Access Compliance Report

Public Rights-of-Way

(Curb Ramps)

Intersection ID: 20662	Main Street: SHARON_RD	Cross Street: HAZELTON_DR	Location: SE
ADA ID: 11E67B463877	Ramp Type: ParaDiag	Initial Pass/Fail: Pass	Overall Compliance: No
		Severity Score: 0.25

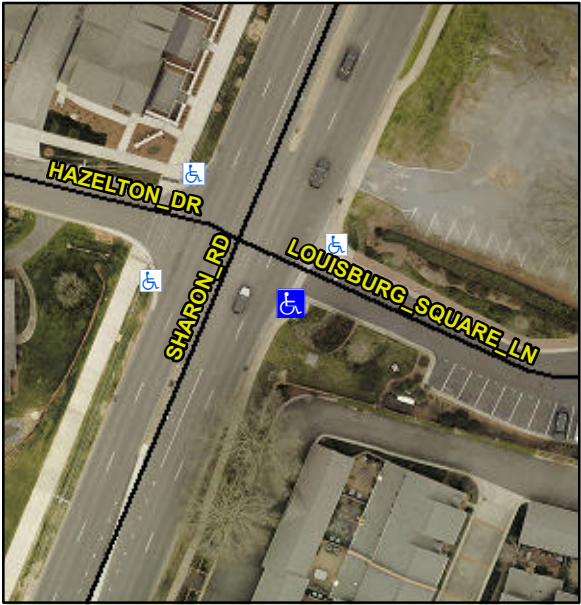
Codes/Mitigation Info/Possible Solution		Field Measurements/Component Compliance			
	Possible Solutions:	Compliance	Description	Data	Compliance
	Remove & Replace Curb Ramp With Two New Directional Ramps or Equivalent. Remove & Replace Gutter.	N/A	Ramp Length LT (in)	41.5	N/A
		Yes	Ramp Width LT (in)	61.0	Yes
<p>Surveyor Notes:</p> <p>RT RP < 5%</p>		Yes	Ramp Slope LT (%)	8.0	Yes
		Yes	Ramp XSlope LT (%)	1.6	No
		Yes	Landing Length (in)	59.0	Yes
<p>PROW/ADA:</p> <p>Not Found, R304.5.3</p>		Yes	Landing Width (in)	48.0	Yes
		Yes	Landing Slope (%)	1.5	Yes
		No	Landing X Slope (%)	3.7	Yes
		N/A	Landing Curb? (Y/N)	No	Yes
		N/A	Shared Landing?	No	
		Yes	Gutter Ponding?	No	Yes
		Yes	Gutter Lip Ht (in)	0.0	No
		N/A	Painted X Walk1?	No	N/A
			X Walk 1 Direction	To NE	
		N/A	X Walk 1 Width (in)	N/A	N/A
			X Walk 1 Slope (%)	0.2	
			X Walk 1 X Slope (%)	2.9	
		N/A	Ramp inside XWalk1?	N/A	N/A
			Road Slope (%)	2.0	N/A
			Road X Slope (%)	0.7	N/A

Yes	Any Obstructions?	No	Yes
			Obstruction Type		
Total Cost:		\$	3950.00		
				N/A	N/A
				Yes	Surface Condition? (G/P)
				Replace	Curb Slope (%)
					16.8
